Addendum No: 7
Date: February 9, 2024
Owner: Northern Health
Stantec # 144320228

Client/Project
Northern Health Authority
UHNBC (University Hospital of Northern BC) -
NAPRA Pharmacy Renovation
1475 Edmonton St, Prince George, BC V2M 1S2

Project No. 144320228	Scale As indicated
Revision B	Drawing No. E010

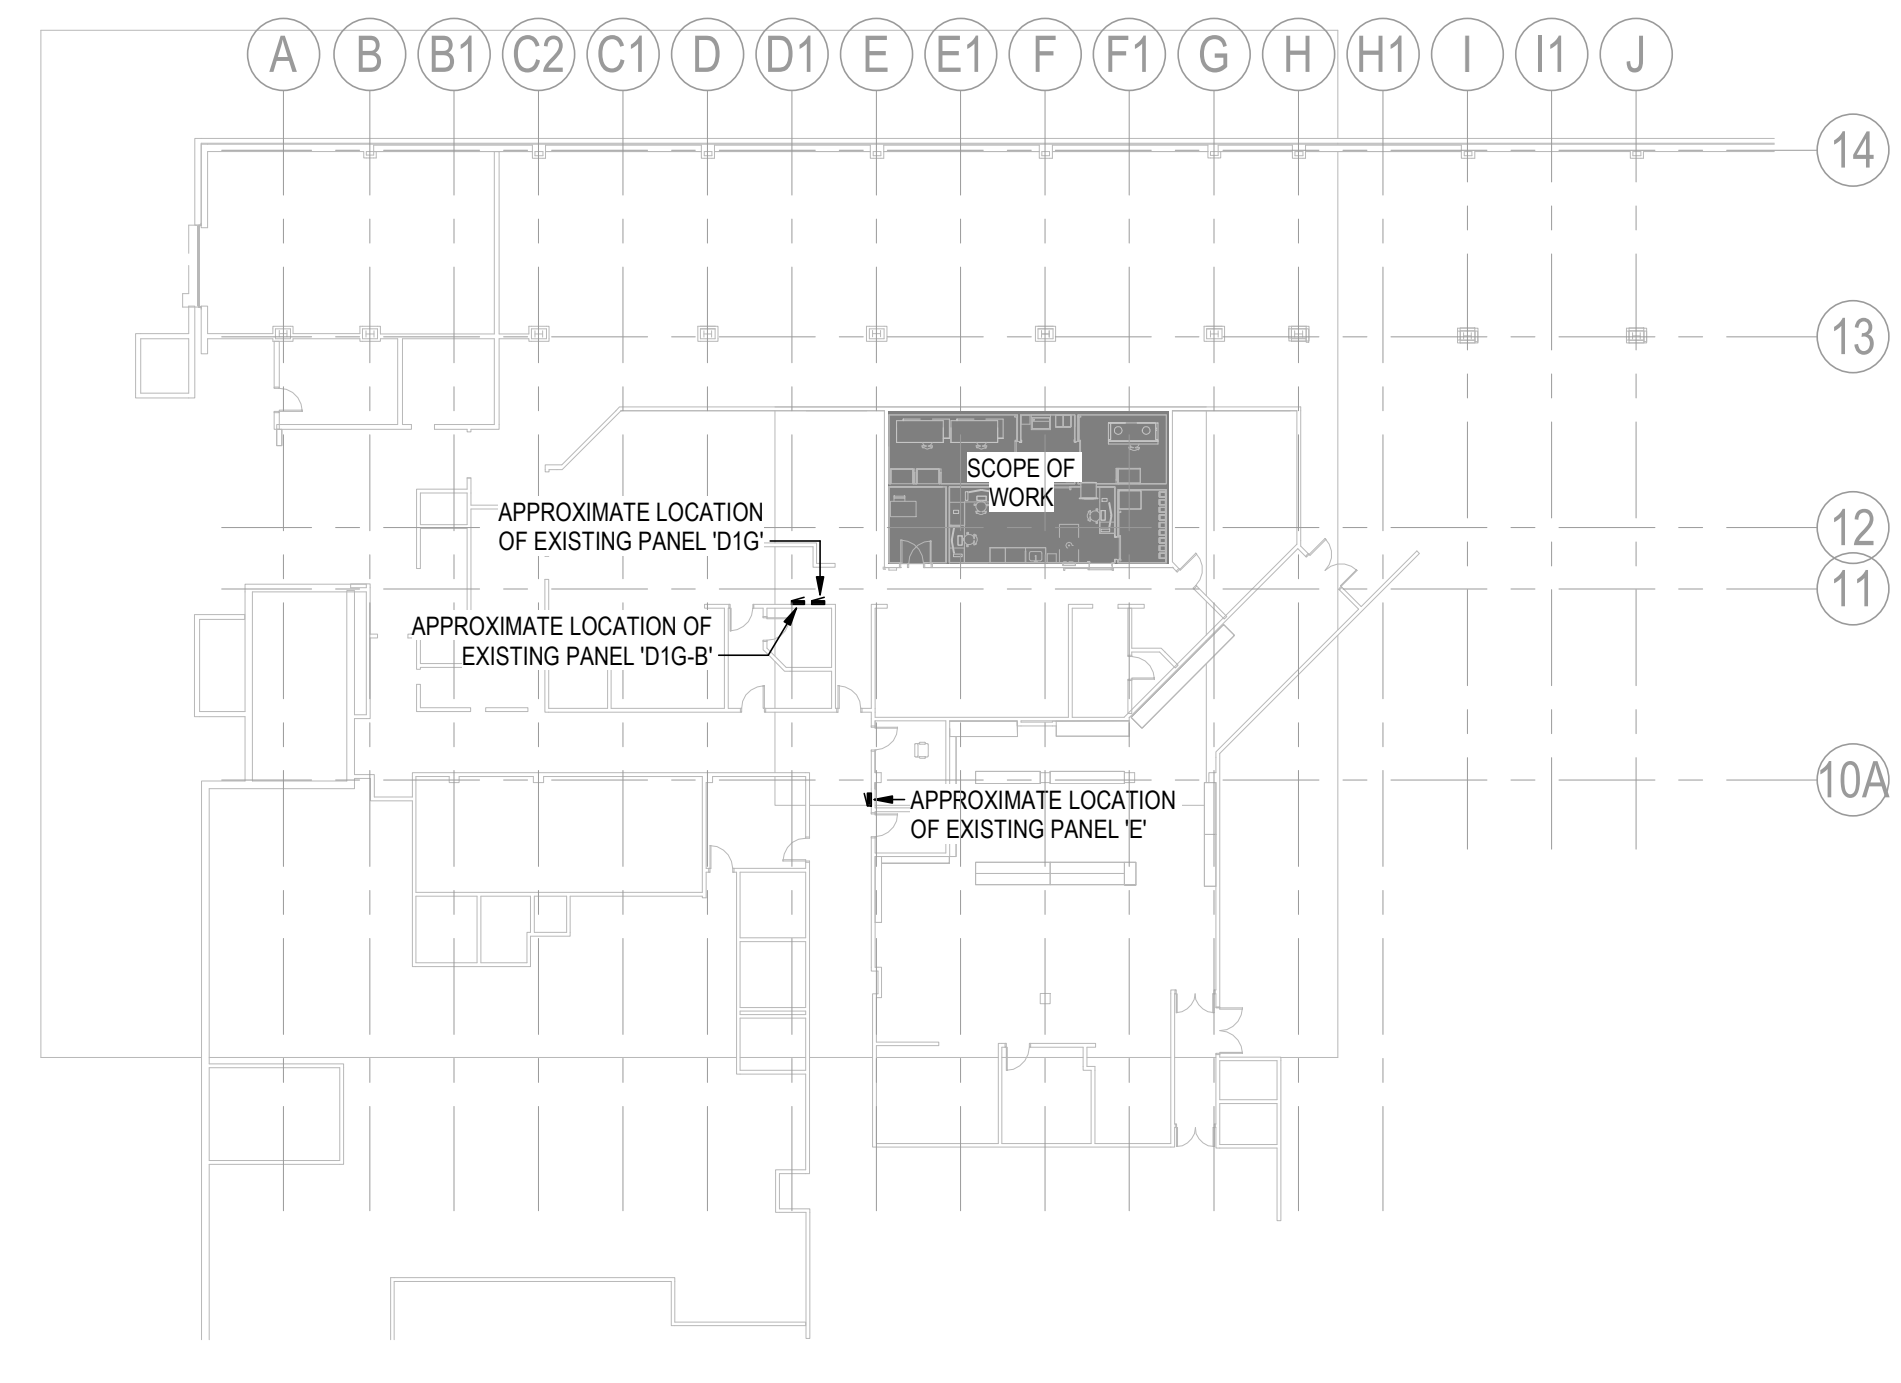
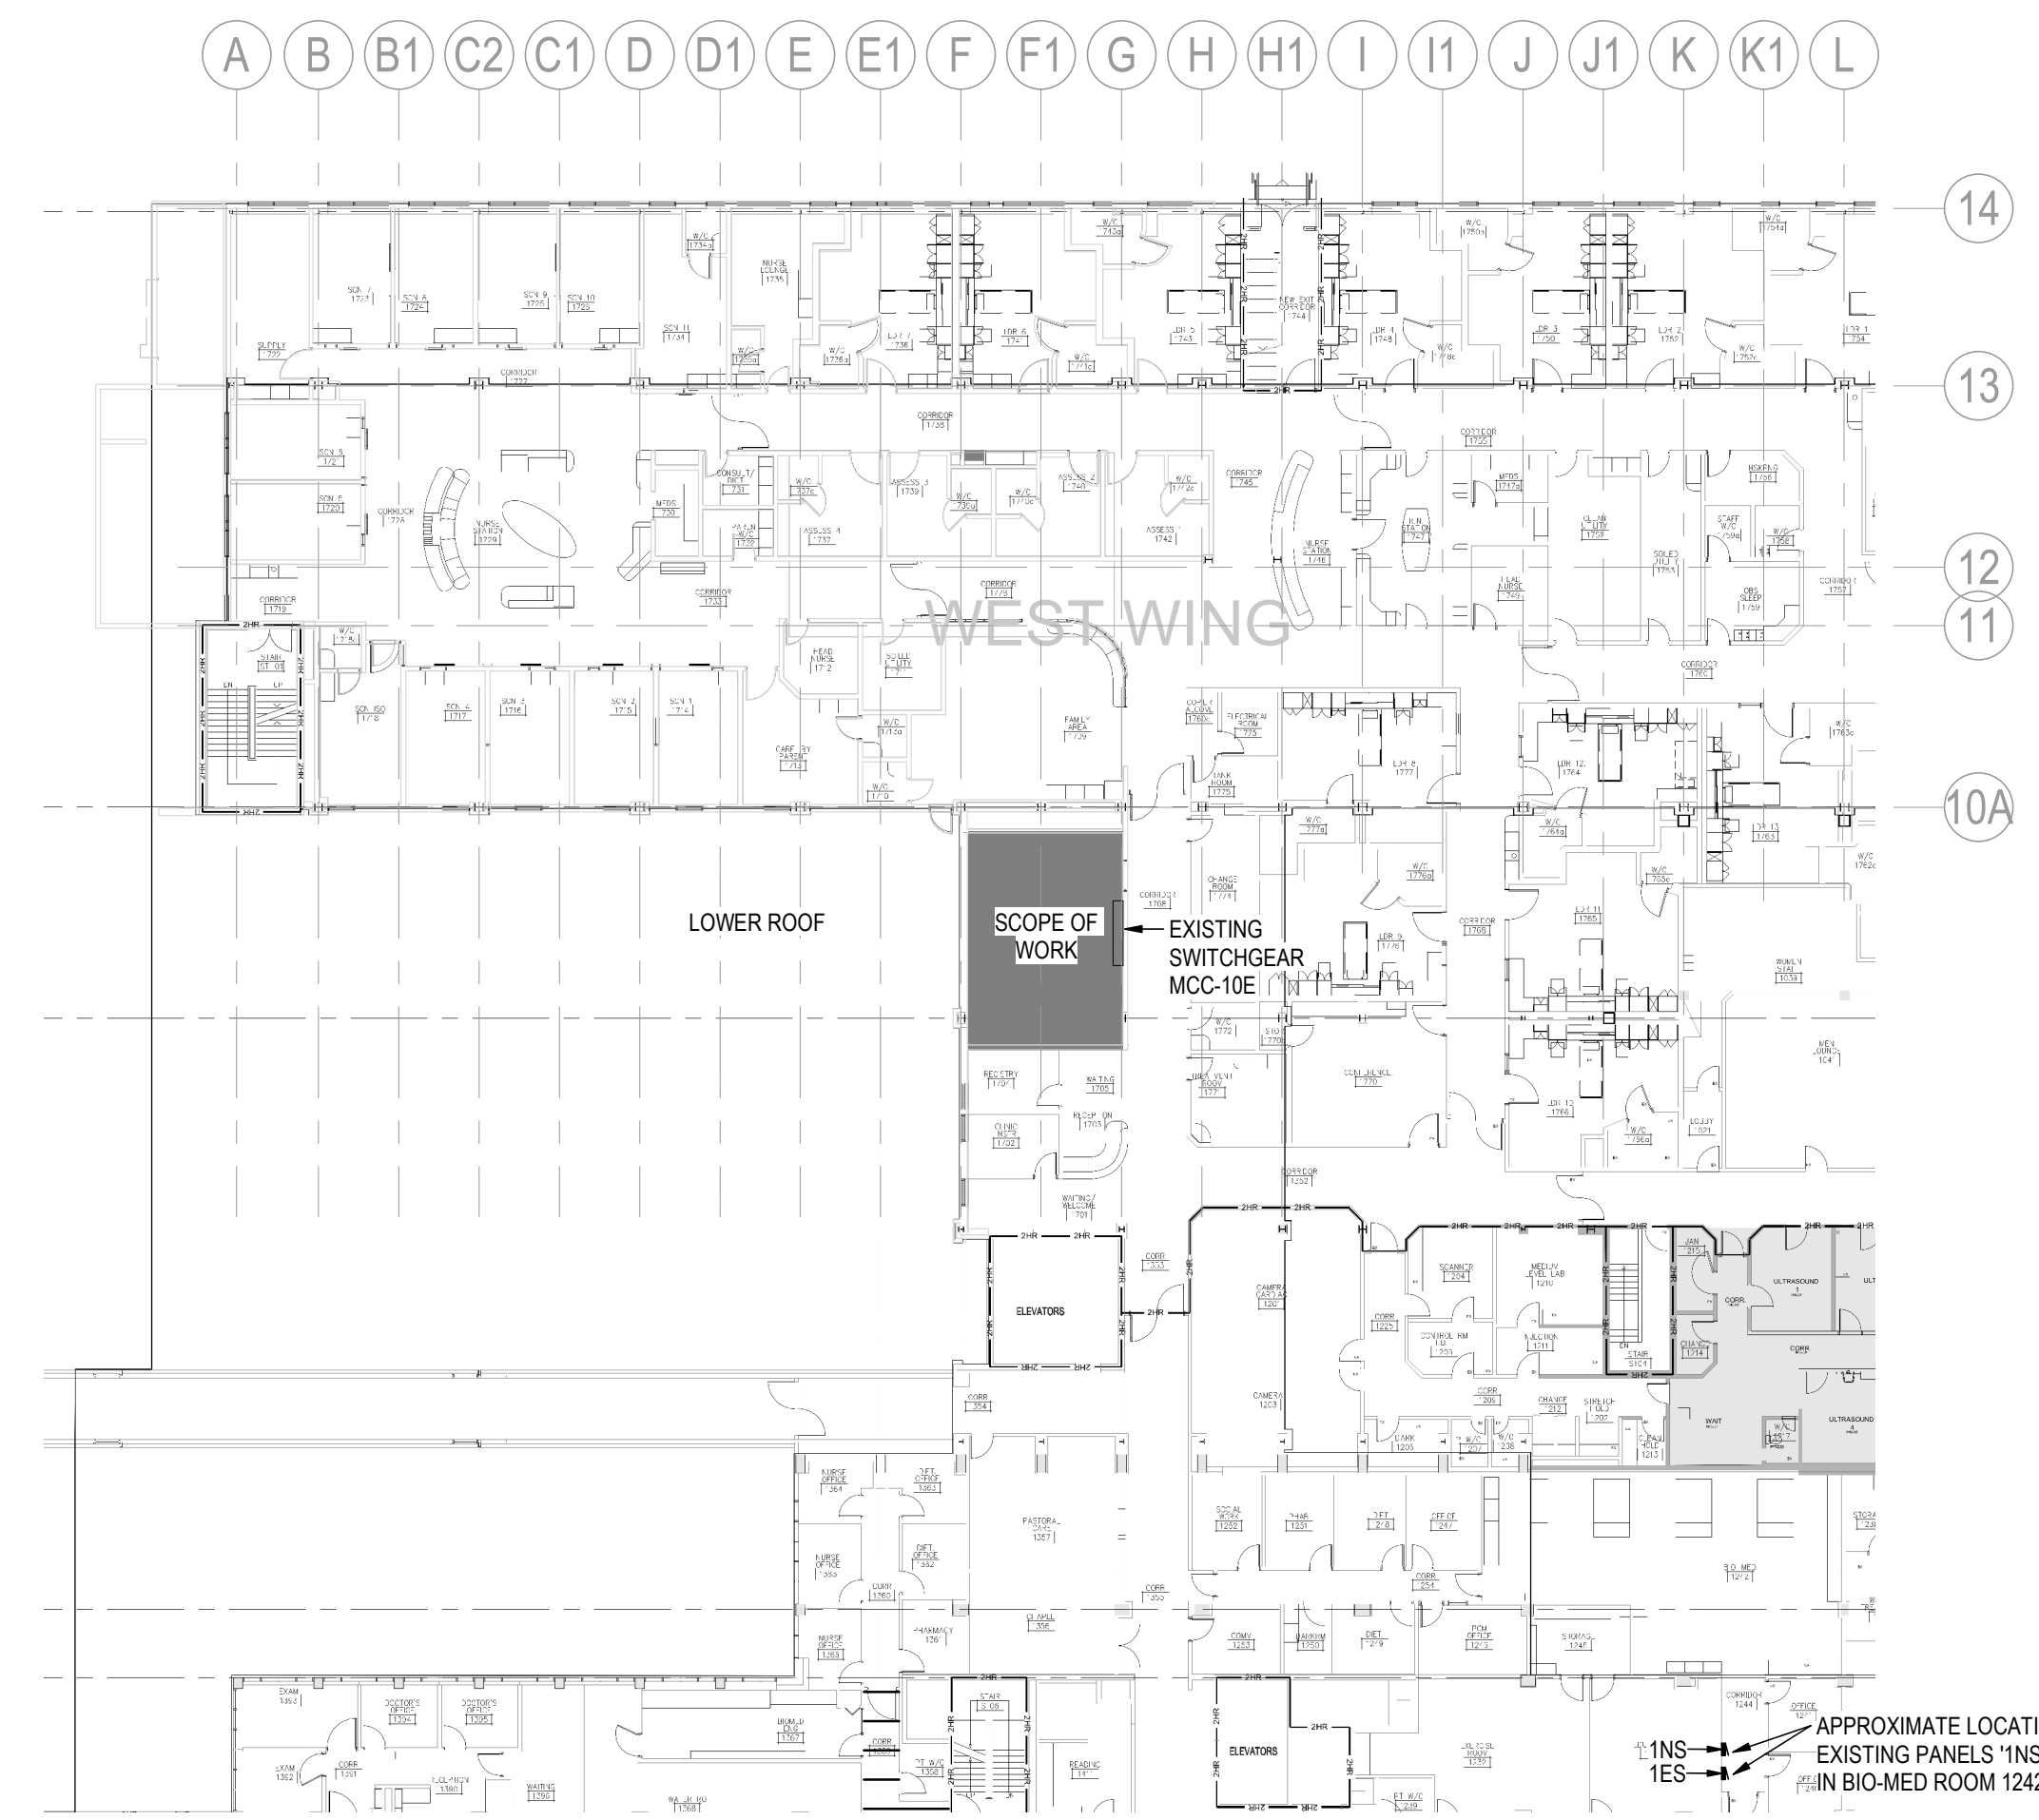
E010 – change breaker for AHU-PH-1, from 25A 3P, to 35A 3P. Change the feeder from 3C#10 AWG Cu to 3C#8 AWG Cu, and the size of the conduit to 27mmC.

Contractor to setup integration to existing BMS (RC Webview), for the lighting controls.

Question: Addendum #3 - #3 Clarification-MCC-10E. Please have electrical engineer contact owner to confirm this breaker space is still available for this project.

Answer: Condition on site shouldn't have changed space still available.
